Peach Bottom Atomic Power Station, Units 2 and 3  
Renewed Facility Operating License Nos. DPR-44 and DPR-56  
Docket Nos. 50-277 and 50-278

Subject: Response to Request for Additional Information Concerning  
License Amendment Request – Application of Alternative Source Term

**License Amendment Request  
Response to Request for Additional Information**

**Alternative Source Term (AST)**

**FIGURE 1**  
PBAPS AST LAR - RAI Response  
Question 18 Supporting Information

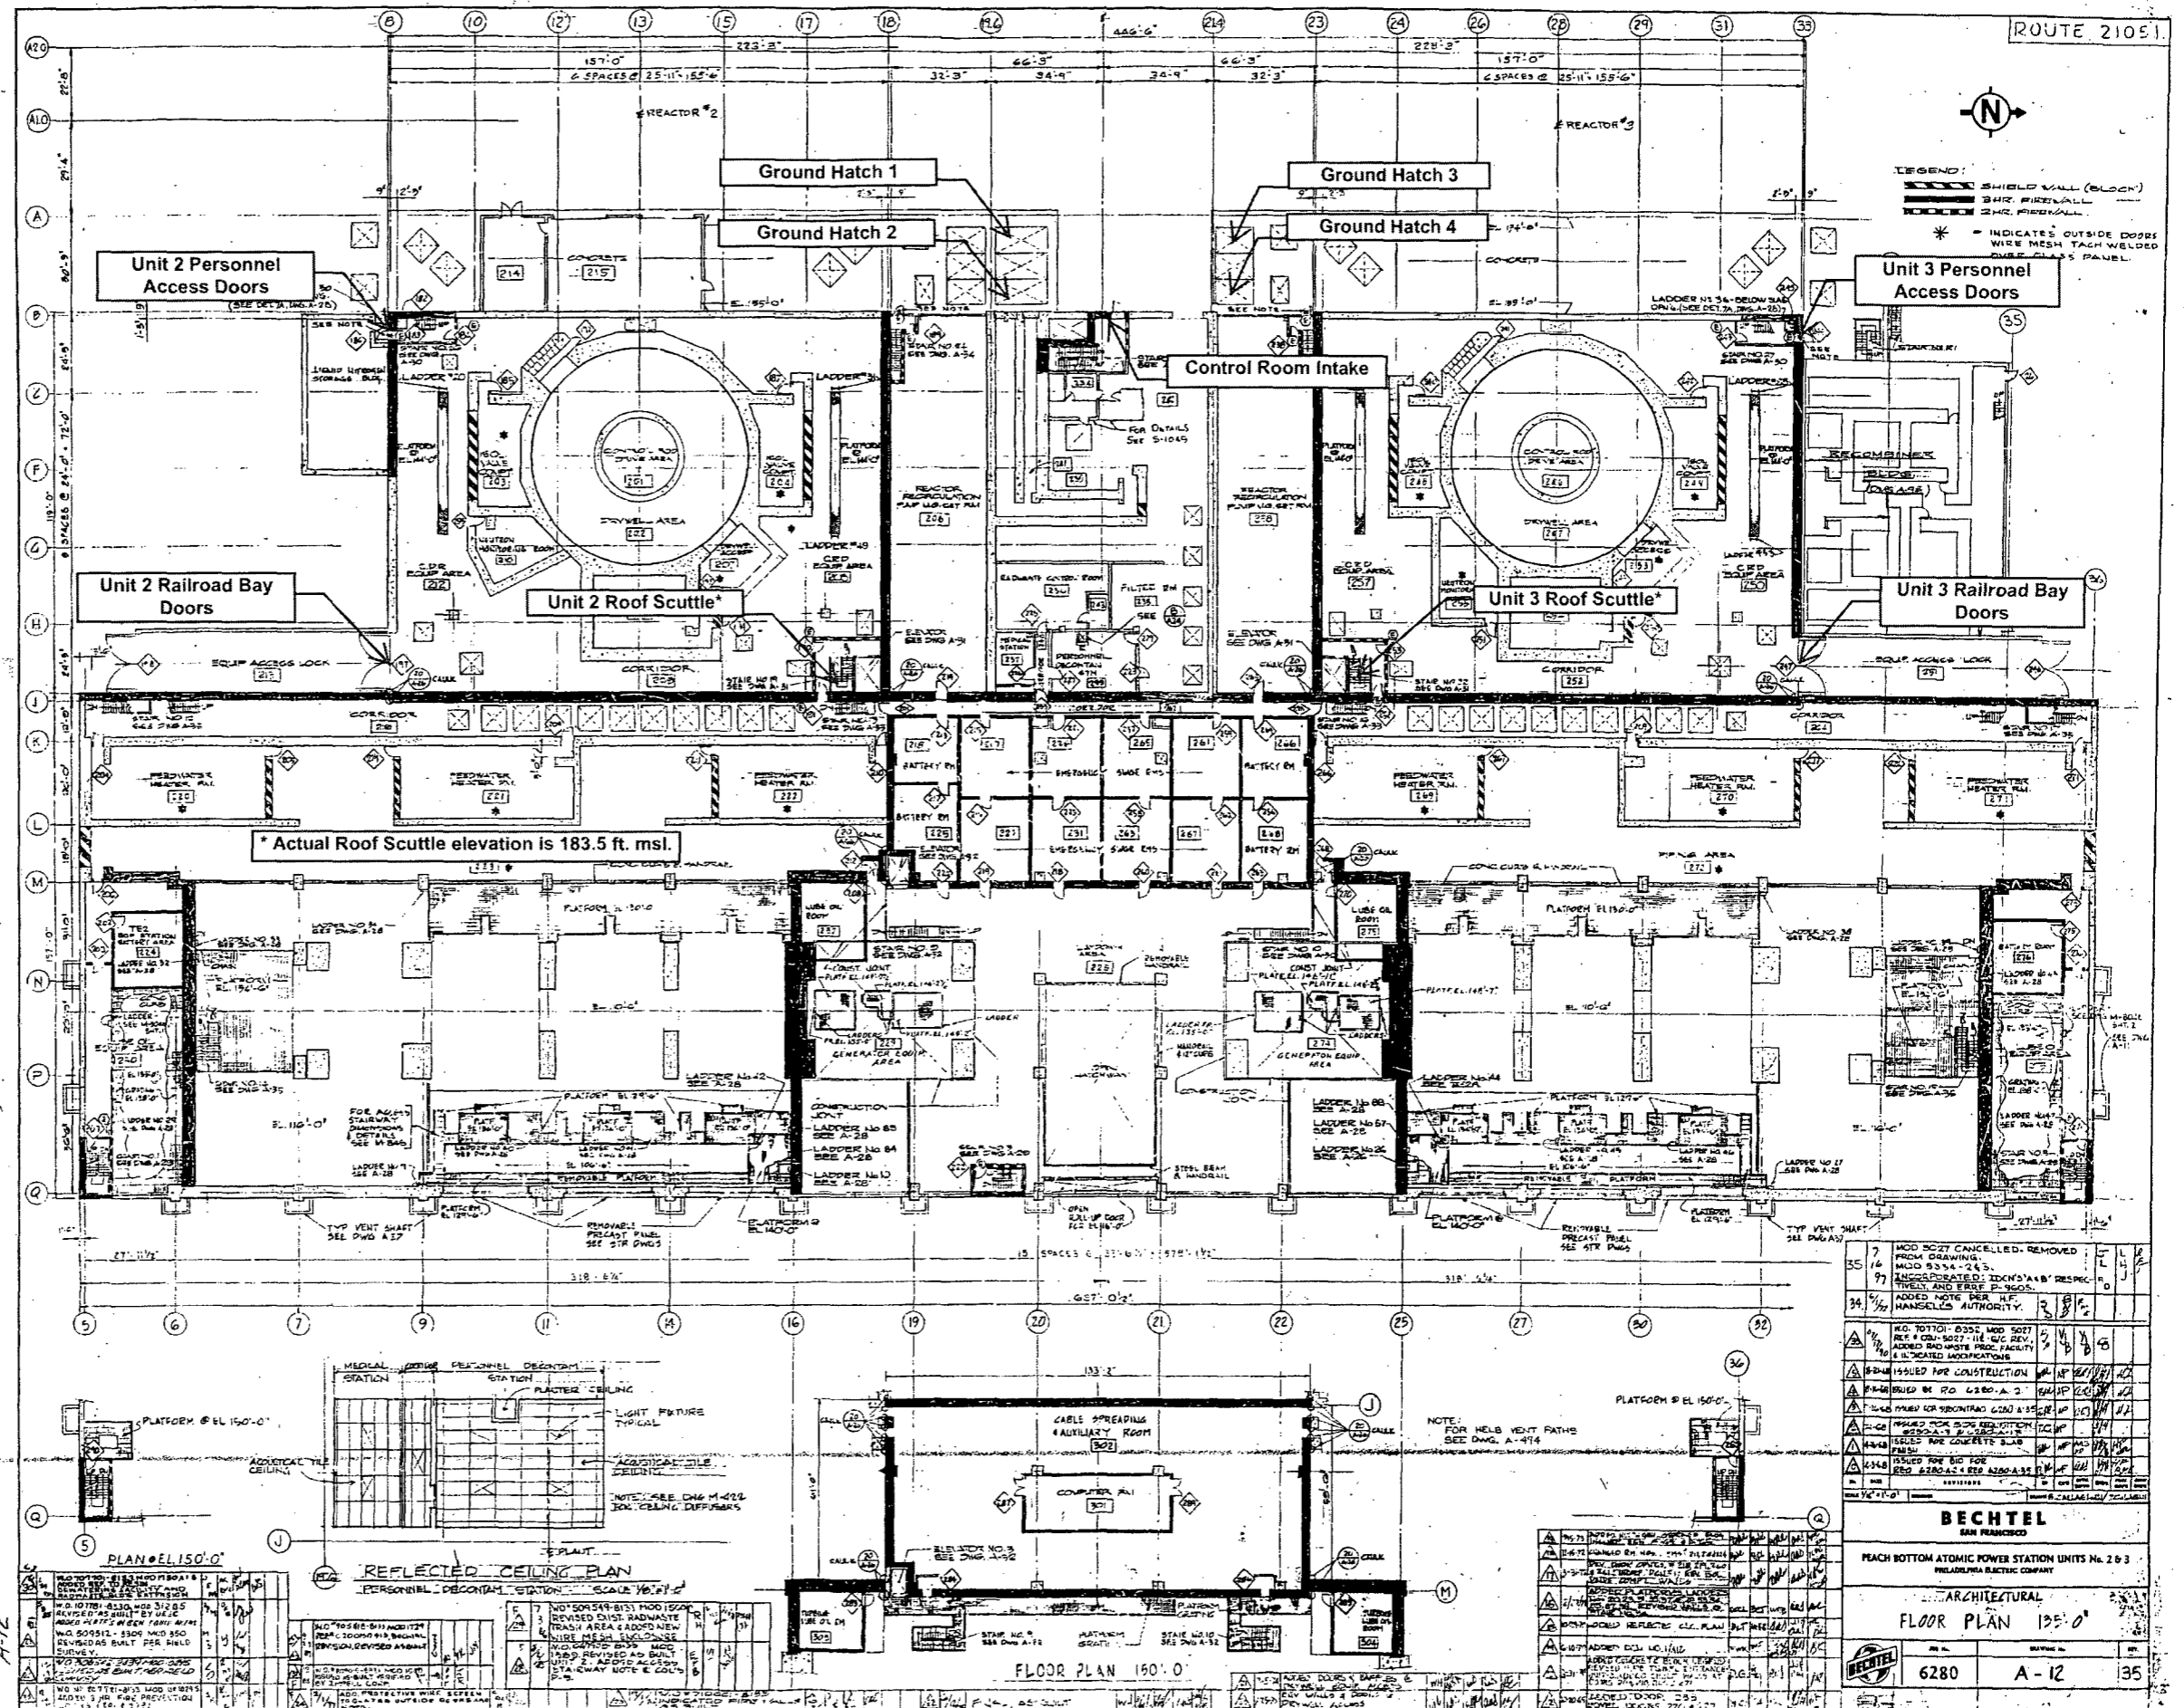
*Figure 3-1 of Attachment G to Calculation No. PM-1055, Revision 2, is a plant plan showing postulated source and receptor locations. What is the scale of this figure? NRC staff had some difficulty regarding the clarity of the figure. Therefore, please provide another copy that more clearly highlights the locations of the sources and receptors.*

Figure 3-1 of Attachment G, which depicts the postulated source and receptor locations, is part of Calculation PM-1059, Revision 2. To address the NRC's request, refer to Figures 1 and 2 in this response, which more clearly highlight the source and receptor locations. Figure 1 is the general arrangement plan for the 135-foot elevation at PBAPS and Figure 2 is a floor plan for the 135-foot elevation. The figures are not to scale since they are reduced copies, but dimensions are depicted for reference purposes.
